Access Compliance Report

Public Rights-of-Way

Intersection ID: 45739	Main Street: REDWOOD_VALLEY_LN	Cross Street: PACIFIC_ECHO_DR	Location: SE
ADA ID: 20978401BD21	Ramp Type: PerpDiag	Initial Pass/Fail: Fail	Overall Compliance: No
Severity Score: 37.5			
Codes/Mitigation Info/Possible Solution		Field Measurements/Component Compliance

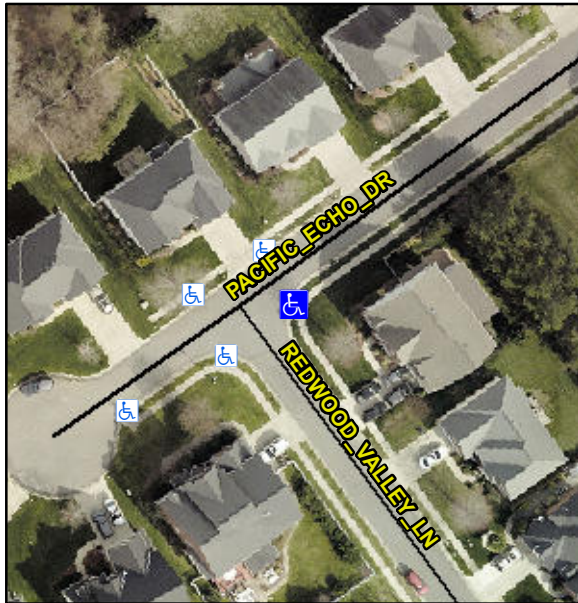
Not Found, R304.2.2, R304.5.3

Remove & Replace Curb Ramp With Two New Directional Ramps or Equivalent.
